Comment:

Editor Note #2.

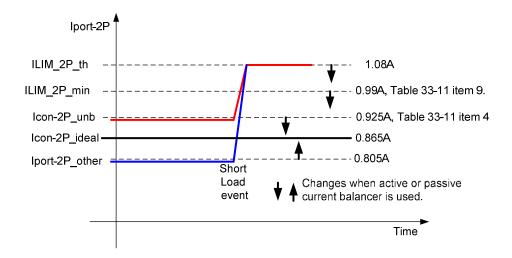
The accuracy of this comment is addressed in the comment marked ED_2 and the comment ED_2 is updated in this comment as follows:

"2. The following case needs to be addressed: The PSE is allowed to use active or passive pair-to-pair current balancing circuitry and the current spec requirements allow it however we need to address the fact that we can't benefit from the advantages of using passive or active current balancing if we are not allowing PSE to use lower minimum values of ILIM-2P, Icon-2P, Ipeak-2P unb than specified in Table 33-11."
